Subject: Adding or Installing a Rearview Camera
Models Years Affected: 2019 - beyond

Models Affected: Chevrolet Silverado/GMC Sierra Full-Size box delete (ZW9) Pickups and Chassis Cabs (NEW body style)

Revision Date: January 14, 2021

Kit P/N 84759864 <u>(for use on a chassis cab vehicle only)</u>		
<u>Contents:</u>		
Note: Kits are not available from Service Parts – Only Individual pieces as listed below		
Component	Part Number	Quantity
Camera	23390515	1
Bracket	84809886	1
Harness	84682148	1
Attachment Clip	84602061	12

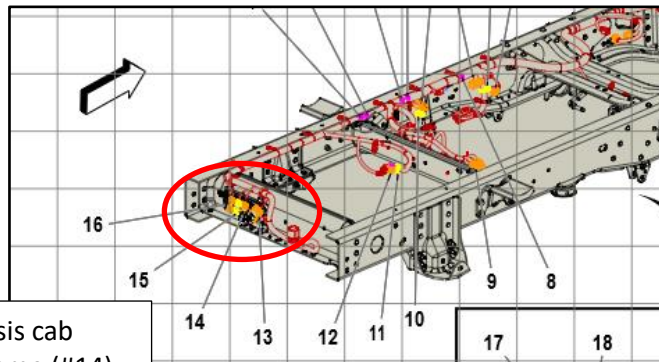
Mating connector on chassis cab models found at rear of frame (#14)
